**Project #20-011
Foothill Residential Subdivision & Rezone
Located at approx. 1250 N. 1300 E.**

Project Name: Foothill Residential Subdivision & Rezone
Proponent/Owner: Nic Porter / Foothill Lofts Residential
Project Address: 1250 N. 1300 E.
Request: Rezone from NR-4 to NR-6 & 46-lot subdivision
Current Zoning: NR-4
Date of Hearing: Feb. 27, 2020
Type of Action: Legislative & Quasi-Judicial
Submitted By: Russ Holley, Senior Planner

**FOOTHILL SUBDIVISION
PRELIMINARY PLAT
SECTION 21, TOWNSHIP 12 NORTH, RANGE 1 EAST**

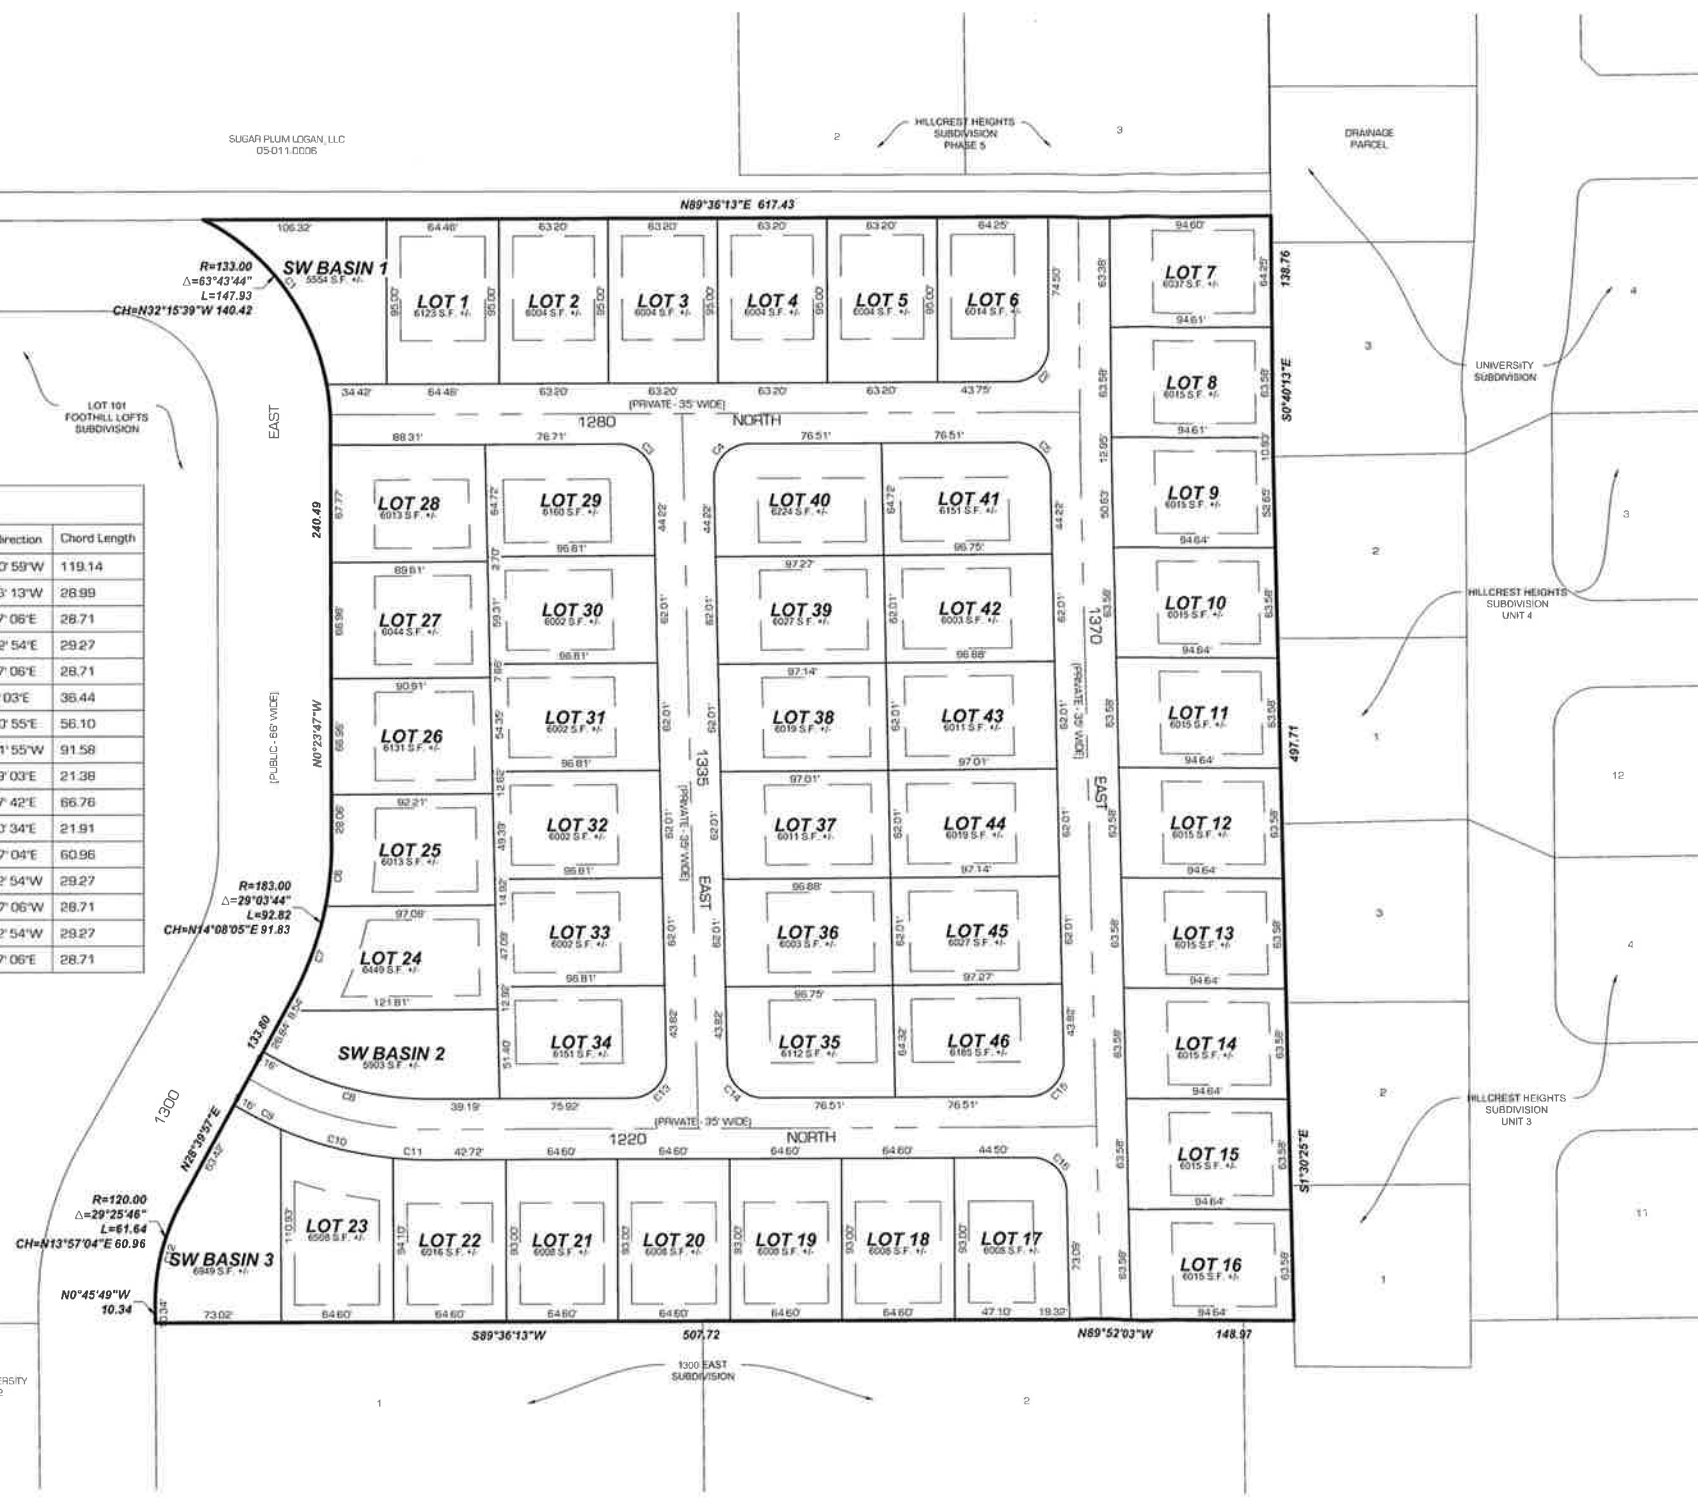
While the LDC does permit private roads, the code specifies that all privately owned streets shall be designed, built, and maintained to the same standard as public streets. Staff finds that the proposed private street cross-section is inadequate for the proposed development. The proposed street cross-section, while found in the City's engineer standards, is intended to be used for small subdivision, such as flag lots, that have only one street connection and 8 or less units. The proposed street cross-section lacks amenities that are expected for residential street in a subdivision of this size, such as on-street parking and sidewalks along both sides of the street. For residential blocks, as proposed in this subdivision, the Logan City engineering standards and Transportation Master Plan specify a 60' street cross-sections. The residential cross-section standard includes two 11.5' traffic lanes, on-street parking, and an 8' park-strip and 4' sidewalk on both sides of the road.

The LDC requires 3 points of connection for subdivisions greater than 20 lots. The subdivision proposes 2 points of connection onto 1300 East and two street-stubs on the north and south side. These stubs are located in areas that would be considered impracticable future street connections. One leads to the back yard of an existing home and the other leads to the middle of the church

property to the south. A subdivision can be approved with less than 3 connections where physical conditions of the site or abutting properties preclude street connection. In this case with extreme topography to the north and existing development in the surrounding locations an exception could be considered. A possible future street stub is located at the northeast corner that could eventually connect through vacant land to 1400 E and to the single-family neighborhoods located to the east. As conditioned, with appropriate street cross-section widths and street grid connectivity, the access and streets meeting the requirements in the LDC.

1. All standard conditions of approval will be recorded with the Subdivision Permit and are available in the Community Development Department.
2. Forty-six (46) new single-family lots and two open space areas are approved with this subdivision permit.
3. All street cross-sections must provide two travel lanes, on-street parking on at least one side of the street, and a sidewalk and parkstrip on both sides of the street.
4. Street trees shall be provided on both sides of all streets every 30’ on center.
5. Three (3) street connections shall be provided. The third connection shall be provided at the northeast corner of this property for future connection to 1400 E.

- Roads between 1300 East and 1335 East shall be a public road and shall be 66' in width. All other roads shall be a minimum of 60' unless approved otherwise by planning commission.

- Provide water shares or an in-leu fee for increase water demand on City system.
- Provide storm water detention/retention per Logan City storm water design standards. This shall include the full retention of the 90% storm event on site and the use low impact design methods for the retention of the 90% storm event.

- The minimum pavement section for this development shall be 3" of asphalt, 4" untreated base, and 12" of granular borrow. Provide a geotechnical report with the California Bearing ratio at subgrade of the pavement section, if less than 5 provide a engineered pavement section.
